WOLLONGONG LOCAL PLANNING PANEL ADDENDUM REPORT | 23 February 2024

DA No.	DA-2023/358
Proposal	Residential - demolition of existing dwellings and associated outbuildings, remove six (6) trees, construction of multi-dwelling housing - six (6) units and Subdivision - Strata title - six (6) lots
Property	11 and 13 St Johns Avenue MANGERTON
Applicant	Infinite Designs
Responsible Team	City Centre Major Development Team
Development cost	\$2,000,000
Lodgement date	3 May 2023
Prior WLPP meeting	5 December 2023

Assessment Report and Recommendation

1 U1,U2,U5,U6 Upper Floor -
Setback Plan
1 : 100

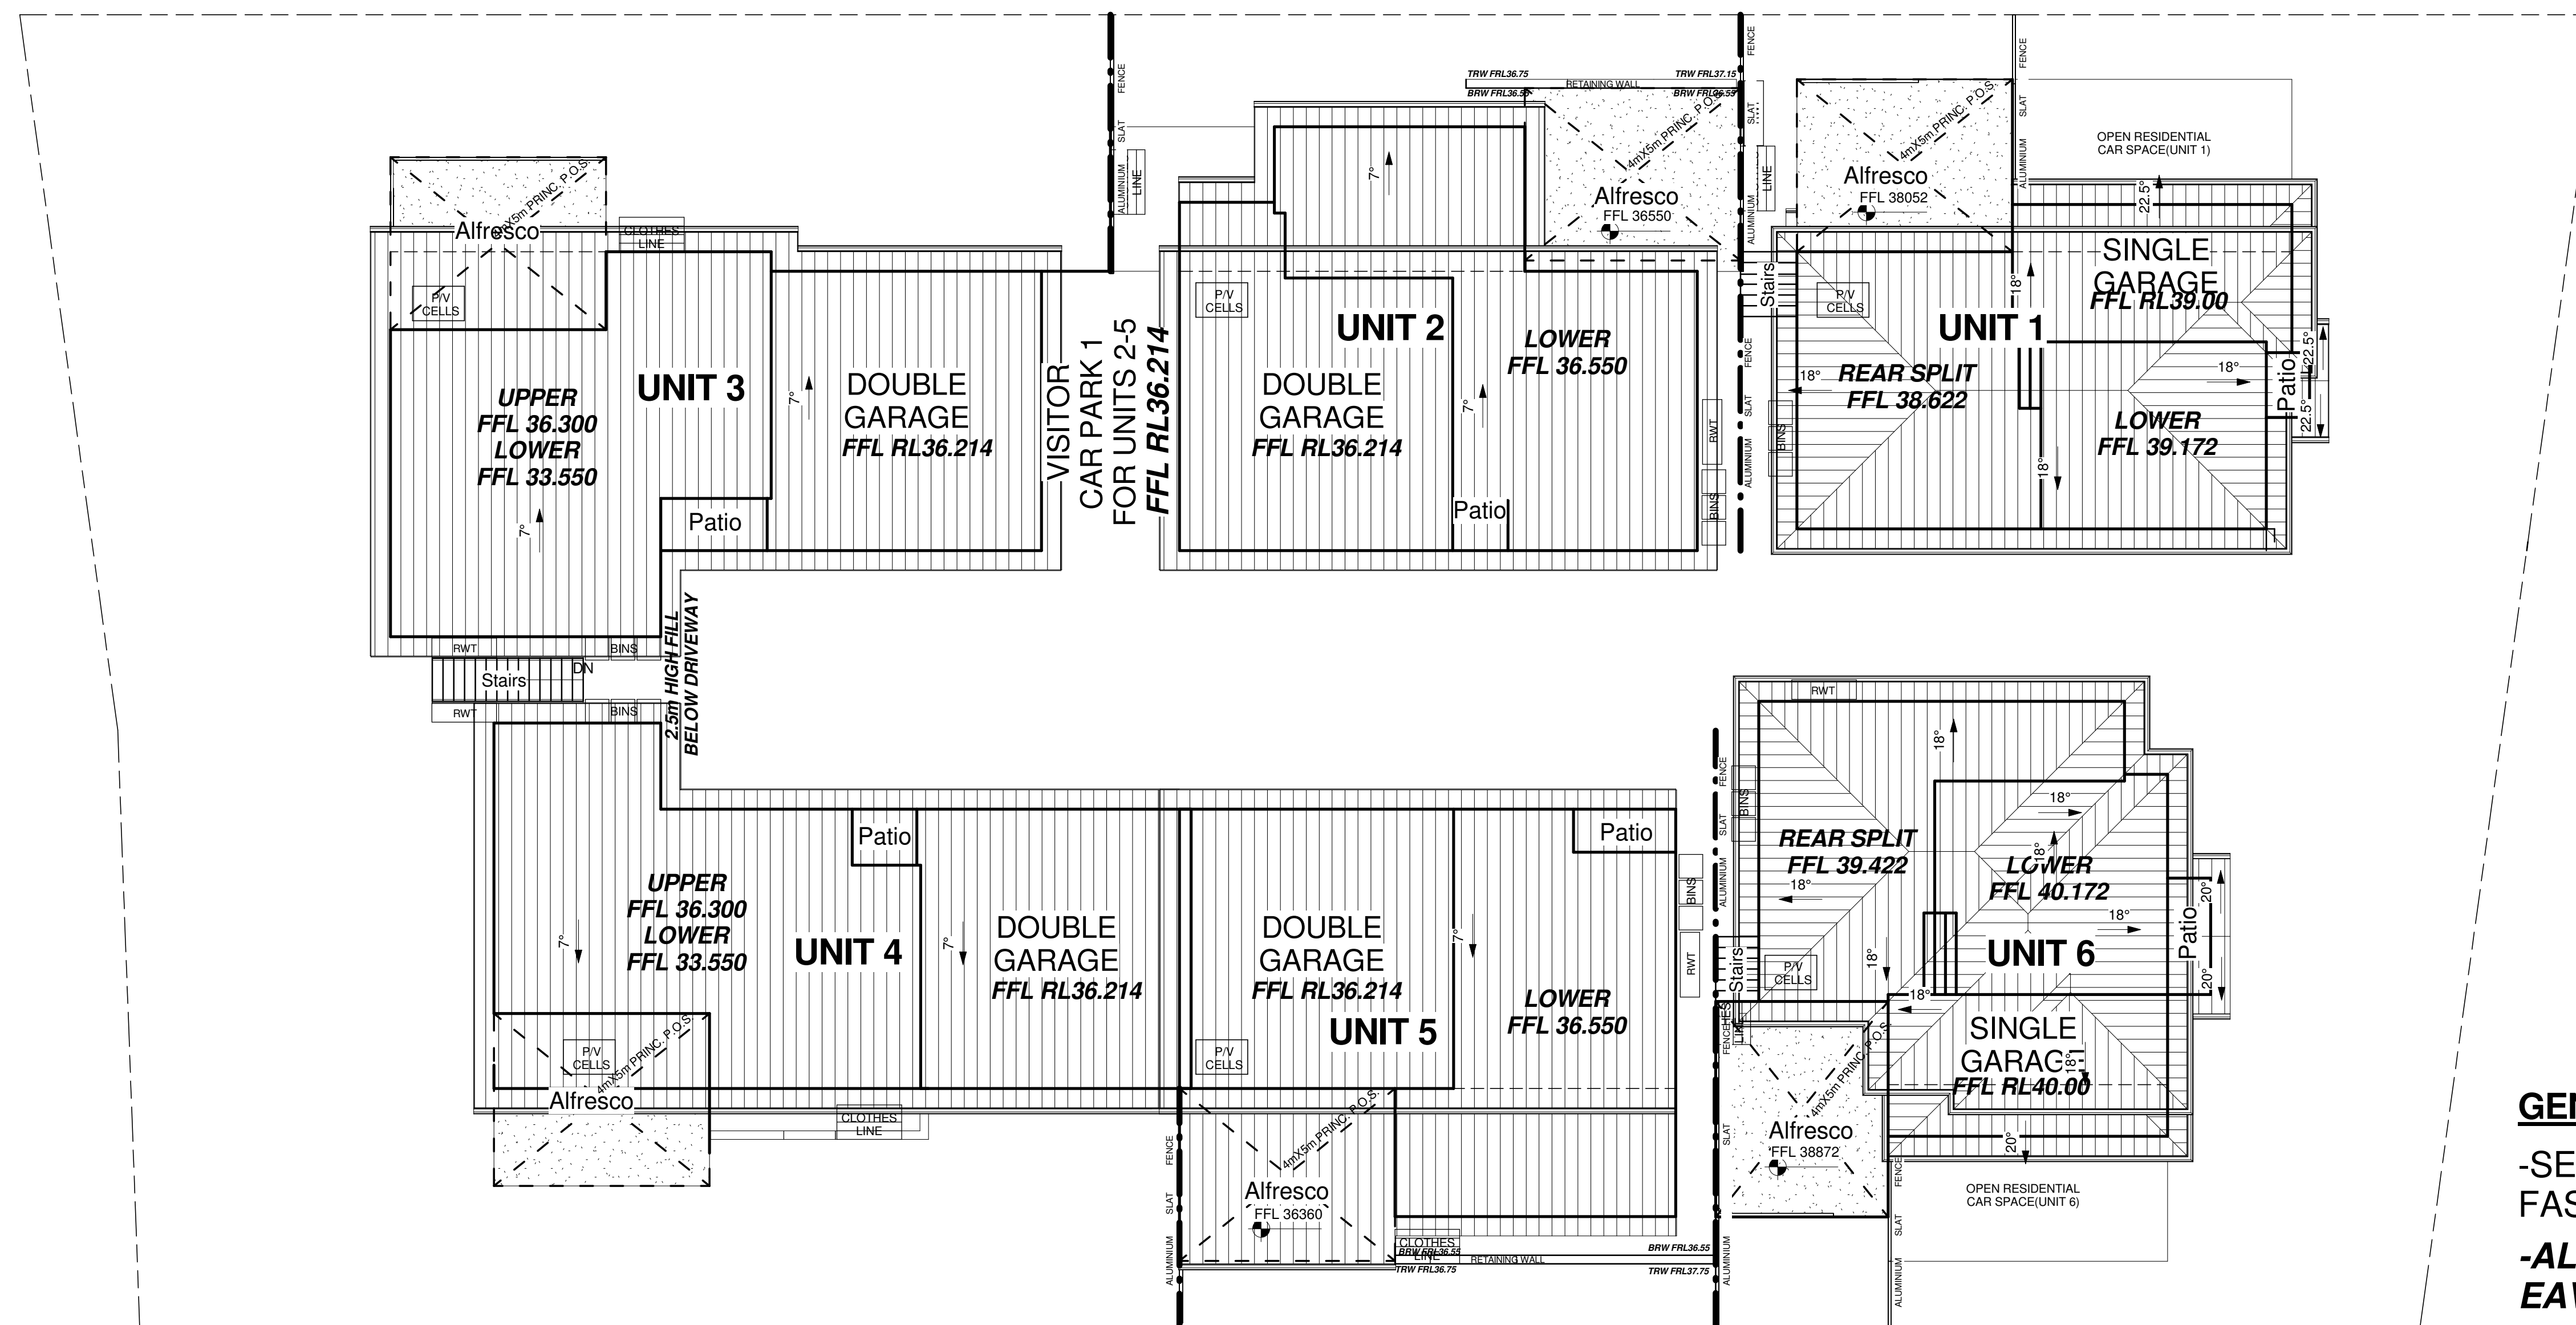
4. Side boundary setback dimensions for ground and first floor of all units to demonstrate compliance.

See marked up plans indicating proposed and required setbacks for units on Plans A09b and A09c.
